Denver Zoning Code Text Amendment
Cherry Creek East Commercial Mixed Use Design Overlay District (DO-9)
Cherry Creek East Residential Design Overlay District (DO-10)
CITY COUNCIL DRAFT - 1/3/2023

This document is a draft of a proposed text amendment to create two overlay zone districts for the Cherry Creek East neighborhood bounded by S. Steele Street, E. Cherry Creek North Drive, E. Alameda Avenue, S. Colorado Boulevard, and E. 1st Avenue. This draft follows a multi-year process led by the Cherry Creek East association with assistance from City Council District 10 and consulting services from Richard (Dick) Farley, AIA and Ellen Ittelson (both former CPD staff members). Councilman Chris Hinds has requested this text amendment to establish the Design Overlays (DO) and a map amendment to apply the overlays as follows:

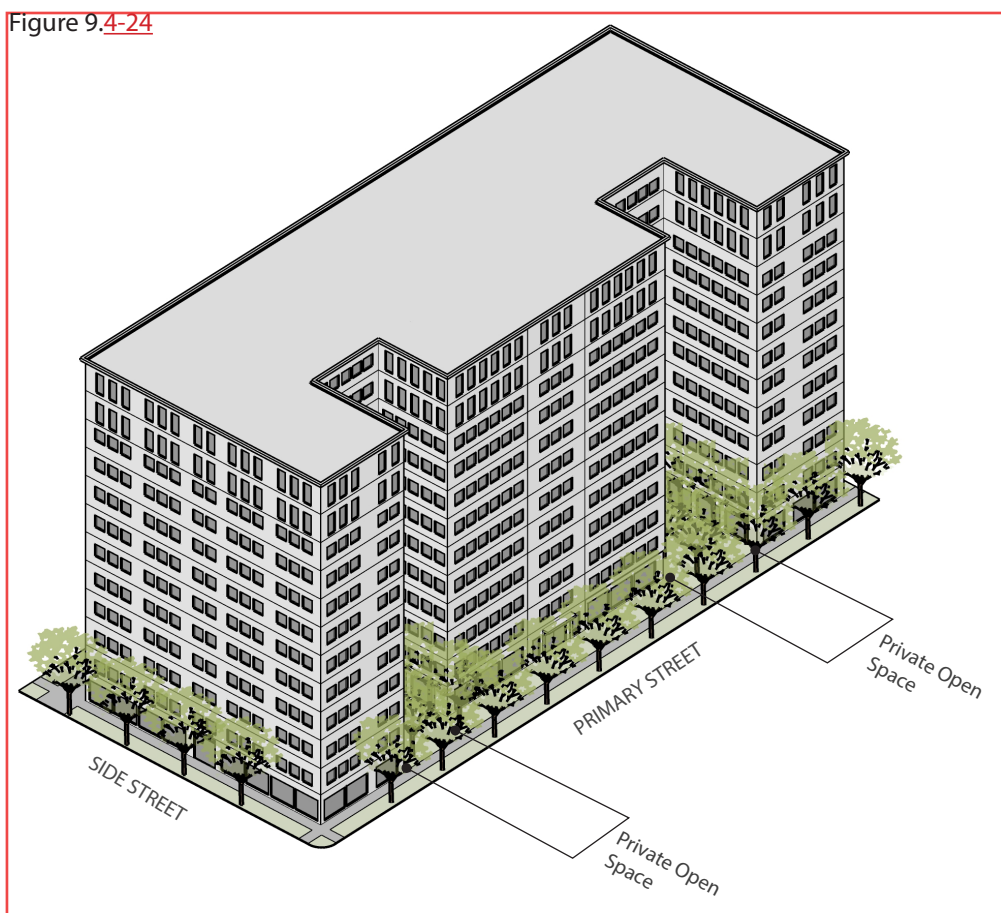
- i. Where a minimum 7 percent of the gross area of a Zone Lot is provided as Private Open Space meeting the rules of measurement set forth in Section 13.1.6.1.B, all Primary Structures on the Zone Lot shall not be required to meet the minimum Street Level Primary and Side Street Setbacks. See Figure 9.4-24.

Figure 9.4-25

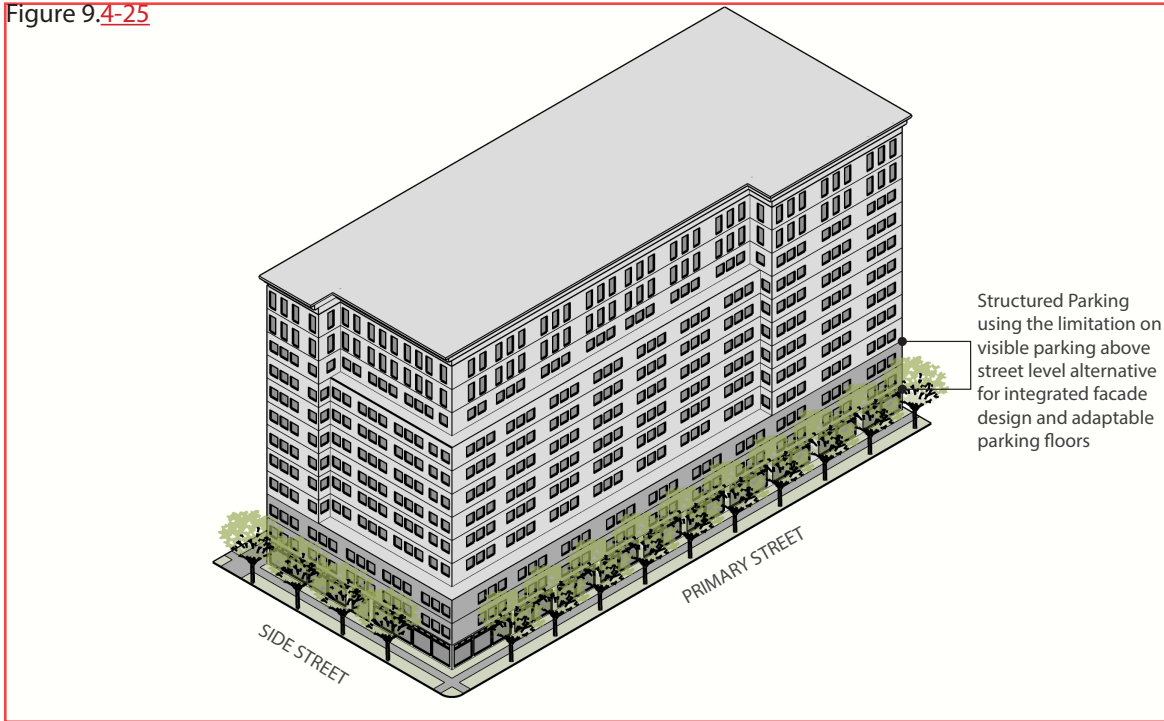
Where 100% of a street-facing building facade containing structured parking meets all the standards set forth in paragraphs i-iv below, the resulting integrated facade design and adaptable parking floors may be used as an alternative to the Limitation on Visible Parking Above Street Level in the DO-9 district. See Figure 9.4-25.

iii. Where the alternative is used, street-facing facades containing structured parking shall be designed with parking floors that are adaptable to other uses for a minimum depth of 30 feet from the Primary or Side Street-facing building facade through use of:

- a) A minimum 12-foot floor-to-floor height, measured from the upper surface of the floor to the upper surface of the floor or roof next above; and
- b) Floor plates that are level except to the minimum extent required for proper drainage; and
- c) Structures that are constructed to accommodate loads associated with office buildings per the International Building Code.

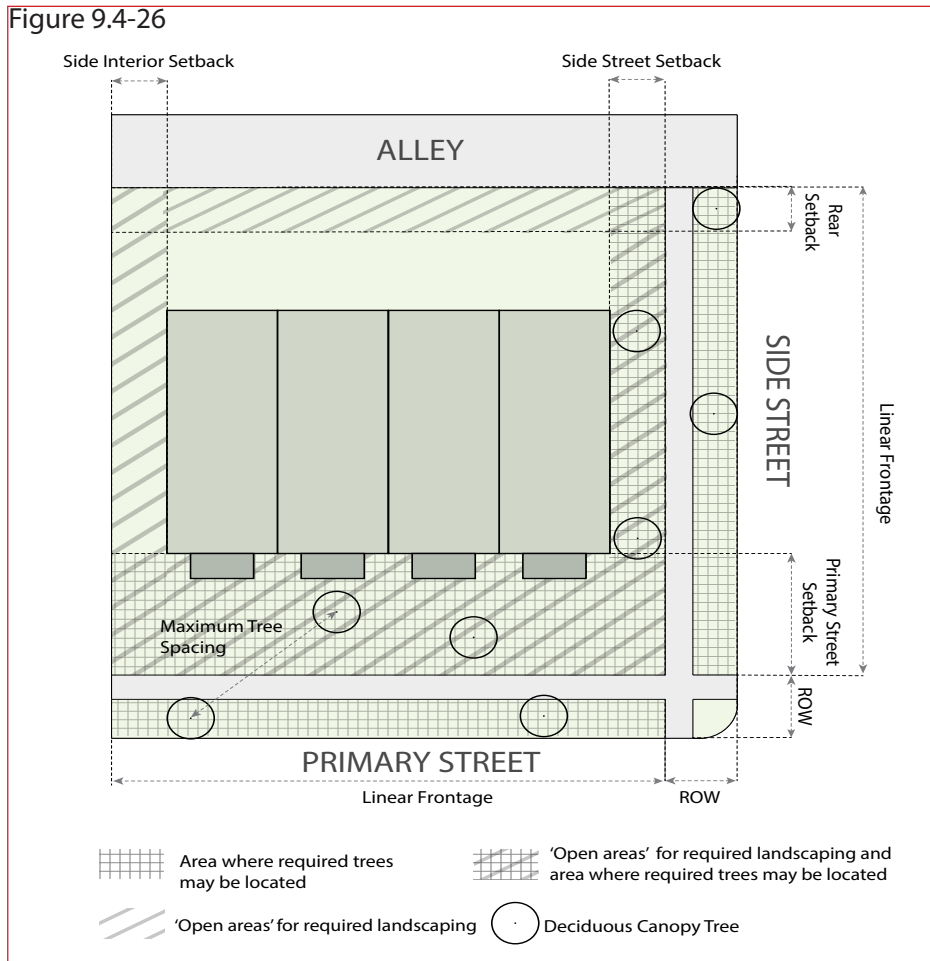
i. A minimum of 60% of the applicable "open areas" shall be landscaped with live planting material and the remaining 40% shall be landscaped with either live or non-live landscaping material, according to Section 10.5.4.6 Landscaping Material Standards. See Figure 9.4-26.

iii. On each Zone Lot, one deciduous canopy tree shall be planted for every 25 feet of linear frontage. Spacing of trees may vary, but the maximum spacing is 40 feet. See Figure 9.4-26.
